# Access Compliance Report Public Rights-of-Way (Curb Ramps)

Main Street: DEERPATH Cross Street: ANTONIO\_PKWY Location: S

ADA ID: RPRK211020152000 Ramp Type: Type 1 - Perpendicular Diagonal Initial Pass/Fail: Fail Overall Compliance: No Severity Score: 15

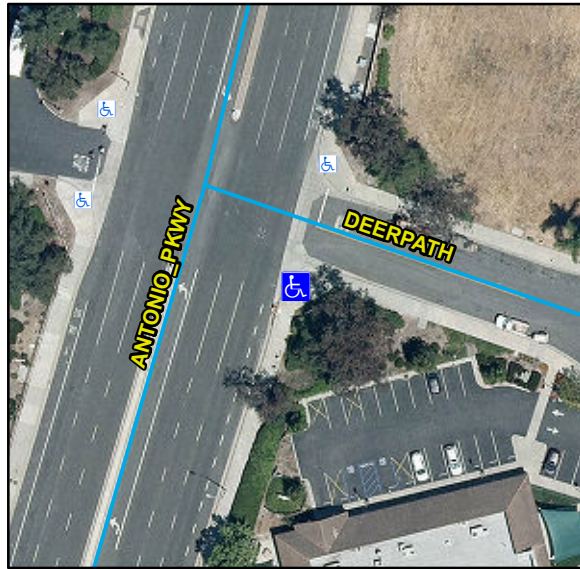
| Compliance | Description                           | Data | Compliance | Description                   | Data |
|------------|---------------------------------------|------|------------|-------------------------------|------|
| No         | Ramp Run Slope (%)                    | 9.8  | N/A        | Flare Slope LT (%)            | N/A  |
| No         | Gutter Lip Height (in)                | 0.25 |            | Road Run Slope (%)            | 0.9  |

Remove & Replace Curb Ramp With Two New Directional Ramps or Equivalent.

R304.2.2, R204.3, R302.7.2, STD 1115
